# Access Compliance Report

## Public Rights-of-Way

### (Curb Ramps)

Intersection ID: 6850	Main Street: BEARWALLOW_CT	Cross Street: WINGDALE_DR	Location:	N
ADA ID: 1B5F57CC63C2	Ramp Type: Perp	Initial Pass/Fail: Fail	Overall Compliance: No	Severity Score: 10

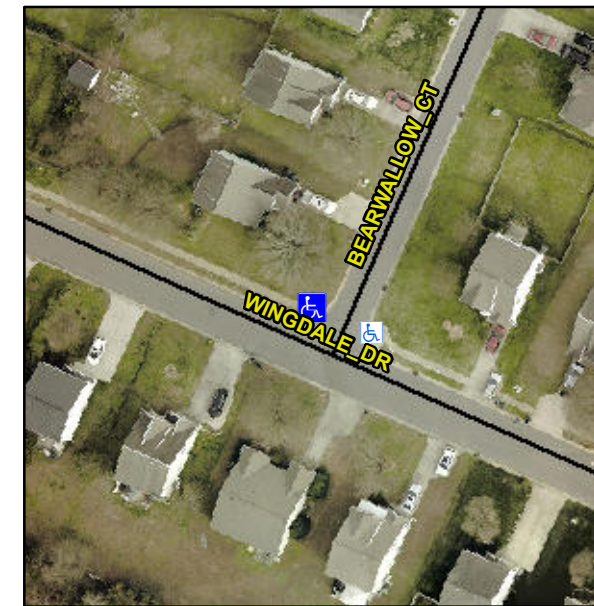
**Not Found, R304.5.1, R304.5.3**

Compliance	Description	Data	Compliance	Description	Data
N/A	Ramp Length (in)	52.0	Yes	Ramp Slope (%)	6.6
No	Ramp Width (in)	36.5	No	Ramp XSlope (%)	4.5
N/A	Flare Type LT	N/A	N/A	Flare Type RT	N/A
N/A	Flare Slope LT (%)	N/A	N/A	Flare Slope RT (%)	N/A
N/A	Flare Traversable LT?	N/A	N/A	Flare Traversable RT?	N/A
N/A	Landing Length (in)	N/A	N/A	DWS Provided?	N/A
N/A	Landing Width (in)	N/A	N/A	DWS Contrast?	N/A
N/A	Landing Slope (%)	N/A	N/A	DWS Length (in)	N/A
N/A	Landing X Slope (%)	N/A	N/A	DWS Full Width?	N/A
N/A	Landing Curb? (Y/N)	N/A	N/A	DWS Offset (in)	N/A
N/A	Shared Landing?	N/A			
N/A	Gutter Ponding?	N/A	N/A	Gutter Slope (%)	N/A
N/A	Gutter Lip Ht (in)	0.5	N/A	Gutter X Slope (%)	N/A
N/A	Painted X Walk1?	No	N/A	Painted X Walk2?	N/A
	X Walk 1 Direction	To SE		X Walk 2 Direction	N/A
N/A	X Walk 1 Width (in)	N/A	N/A	X Walk 2 Width (in)	N/A
	X Walk 1 Slope (%)	3.5		X Walk 2 Slope (%)	N/A
	X Walk 1 X Slope (%)	0.7		X Walk 2 X Slope (%)	N/A

**Remove & Replace Entire Ramp.**
